UNITED STATES PATENT AND TRADEMARK OFFICE

10/568,744

Office Action Summary	Application No. 10/568,744	Applicant(s) ISHIZAKI ET AL.	
	Examiner Matt Benvenuti	Art Unit 4159

DETAILED ACTION

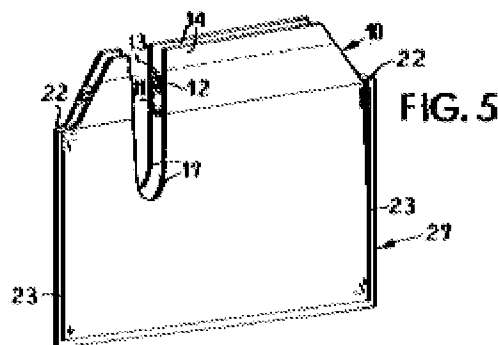
8. In re Claim 7, Boeckmann et al (Figure 5, Shown above) teaches a plastic bag with:

- A zipper (10) on a inner surface of an upper opening portion (Figure 5) of a bag body (27) made of a plastic film (Column 2, Lines 48-52)

- the zipper (10) having a groove (13) and a protrusion (12) engaging with and disengaging from each other wherein (Column 2, Lines 32-39)
- at least both sides of the bag body are fused or melted (23); and
- the both sides of the bag body in the upper opening portion, where the side of the zipper are located, are not fused (Figure 5)

- A zipper (10) on an inner surface of an upper opening portion (Figure 5) of a bag body (27) made of a plastic film (Column 2, Lines 48-52)
- the zipper (10) having a groove (13) and a protrusion (12) engaging with and disengaging from each other wherein (Column 2, Lines 32-39)
- at least both sides of the bag body are fused or melted (23); and
- cut-offs (21) are made at the both sides of the bag body(Once attached to the bag the web (11) becomes part of the bag body) in the upper opening portion where the zipper is provided

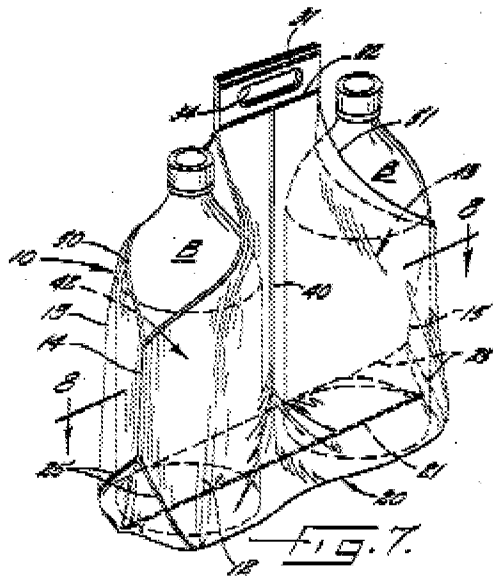
18. In re Claim 17 and 18, Boeckmann et al teaches the claimed invention except for a plastic bag wherein a front film and a back film composing the bag body are fused together along a vertical line, so that a plural number of chambers are formed. Dancy (Figure 7, Shown above) discloses that it is known in the art to provide a seal (40) between the front (12) and rear (13) wall of a bag to create multiple compartments (Column 3-4, Lines 64-3). It would have been obvious to one having ordinary skill in the art at the time the invention was made to provide the bag of Boeckmann et al with a seal between the front and rear wall as taught by Dancy, in order to create a bag with multiple compartments.
